Your ref: 2013/2365/L

Dear Ms. Pound,
Fencing at main entrance to Holly Village

RESPONSE TO PLANNING APPLICATION No 2013/2365/L

Location of steel pole in 'test post' by U.F.-
eccentricity renders methodology impractical.

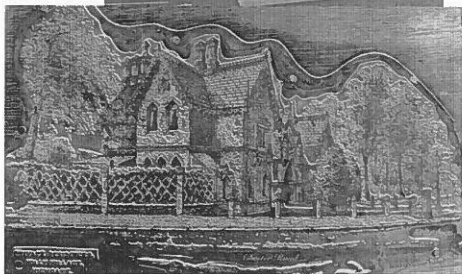
In U.F.'s proposal drawing, note the size of joints and the sizing of stone that indicates close association with the steel pole set in the timber post. Now compare this drawing with the photograph of the so-called 'test post'. Note that the pole, set in resin, has not been placed centrally, key to their concept of very small pieces of stone, cut to shape, fitting around poles less than 15x15 cms in plan that would otherwise be exposed between ground level and the modified bottoms of posts.

Figure 3. Illustration of how the restored posts are to be resealed.

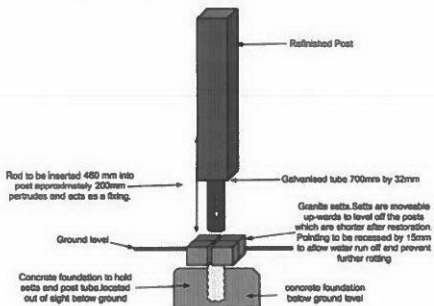
- The positioning of the granite setts has not allowed for the whole range of the finished heights of the posts.

HOLLY VILLAGE
FENCE OUTSIDE No 1402
Scale = 1:10
Dimensions = centimeters

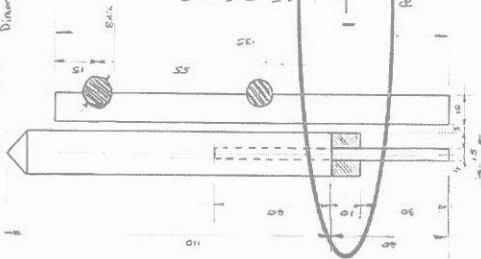
It is proposed (through Urban Foresters) that in order to maintain some sort of consistent finished level for the tops of the posts, that very small pieces of stone are inserted beneath the posts to make up the differences in net post heights. This is a bizarre proposal, making a mockery of the original design and doubtful even of good execution, given the company's flagship project as an example- a cobbled driveway at 9 View Road, Highgate, N6 6DJ. Here Urban Foresters have installed what the company's head tells me is a 'Victorian' driveway. In fact, they have used granite paviors with extraordinarily wide joints- compare this with the real Victorian paving in the archway at Holly Village.

The proposed solution for fixing of the teak posts is sketchy and not comprehensively described. There is no 3D drawing of the proposal and the drawings that are provided are somewhat ambiguous.

The teak posts fit neatly in the ground between large granite slabs- inserting four tiny stone pieces beneath each post might have suited an otherwise ordinary fence but not for a listed Grade II* building.

In the proposal, the vertical chestnut posts are set very close to the teak posts.

A scaled elevation of posts S1- S5 is needed for a better understanding of this proposal.
